UPPER TRISHULI-1 HEP (216MW)

Client		Doosan Heavy Industries & Construction	
DHI's Subcontractor		Power Construction Corporation of China	
Reply comments			
Subcontractor	Power Construction Corporation of China		
Title of Document	Layout Drawing Investigation Tunnel for Powerhouse Rev.A		
Document No.	TJ/UT1/OUT-08	Reviewed Note No.	RN-0010
		Present Review status	RR
Date of Documents	20.09.2021	Received	20.09.2021
Reply Comments	RC-0004	Present Reply date	31.10.2021

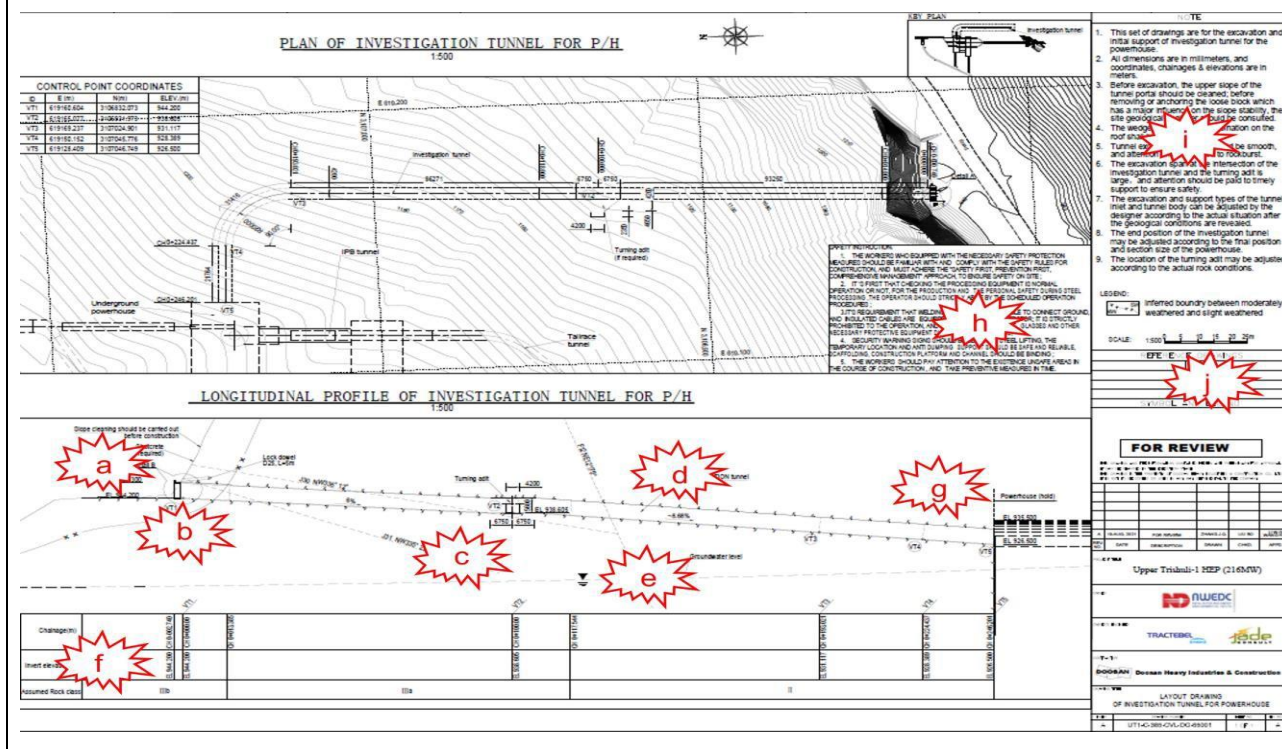
- a) Support details at the portal must not be shown.

- b) See Review Note on the Construction Drawings of the tunnel. There refer to the confusing chainage at the portal.

- c) The turning bay does not need to be horizontal, as it is also indicated that the selected location may change. This would lead to new gradients along the tunnel and would require redesign.

- d) Select one uniform gradient for the entire tunnel, wherever the turning bay will be located.

- e) Geological structures must not be indicated in this drawing. A small table of major joints sets is sufficient.

- f) Provide one row with "Overburden Thickness" (= rock cover thickness).

- g) It is for construction reasons preferable that the tunnel enters the Powerhouse at its roof, i.e., the roof of the tunnel, when entering the Powerhouse is at the same elevation as the roof of the Powerhouse. Countercheck with the current Powerhouse design and revise.

- h) Safety instructions are not needed on a layout drawing. Delete. They should appear in the Method Statement for the tunnel.

- i) See separate notes below.
- j) Provide the reference drawings/documents in this list.

a) Delete this comment. It is related to construction and not to layout. Such comment should appear in the Method Statement or on construction drawings.

b) Same as under a).

c) Same as under a). Note, there is no rock burst to be expected in the project, so far.

d) Same as under a).

e) Modify this comment: The Designer shall provide alternatives and options in the tunnel support design, so that the support can be adjusted in case geological conditions are varying.

Reply: The support details at the portal has been canceled. This is the layout drawing investigation tunnel for powerhouse, which mainly reflects the overall layout scheme. For the detailed support of the portal, see UT1-C-385-CVL-DG-65002-01 ~ 02.

Reply: Generally, as an auxiliary means of mapping, chainage mainly plays a role in recording the relative relationship between positions. In the design of tunnel, the position of the portal is uncertain because of the quality of surrounding rock or the adjustment of the design. If the chainage of the portal is always kept as 0, the value of other chainage may be adjusted frequently, which is troublesome and unnecessary. Therefore, in engineering practice, reference point is more used as the marking method of 0 chainage, e.g. the chainage of reference point is 0.000, which can be recorded as CH0±000.000; Along the forward direction, the chainage is marked with a positive value, such as CH0+100.00; Against the forward direction, the chainage is marked by a negative value, such as CH0-002.740.

Reply: Accept and modified.

Reply: Accept and modified. Now the uniform gradient for the entire tunnel is adjusted to 7.17%.

Reply: The occurrence of joints and mechanical parameter of joints in the investigation tunnel has been added to the drawings.

Reply: "Overburden Thickness" has been added to the properties table.

Reply: Because the length of the crown rock dowels of the powerhouse is 8m, in order to facilitate the installation of the crown rock dowels during the excavation of the first floor of the powerhouse, we plan to excavate the first floor of the powerhouse to 9m, and we plan to use double-boom jumbo for drilling construction. Considering the convenient construction traffic, we suggest that the bottom elevation of the ventilation tunnel should be consistent with that of the excavation of the first floor of the powerhouse.

Reply: Agree to delete.

Reply: Accept and modified.

Reply: Agree to delete.

Reply: Agree to delete.

Reply: Agree to delete.

Reply: Agree to delete.

Reply: The excavation and support methods of the tunnel portal can be adjusted according to the actual situation after the geological conditions are revealed.
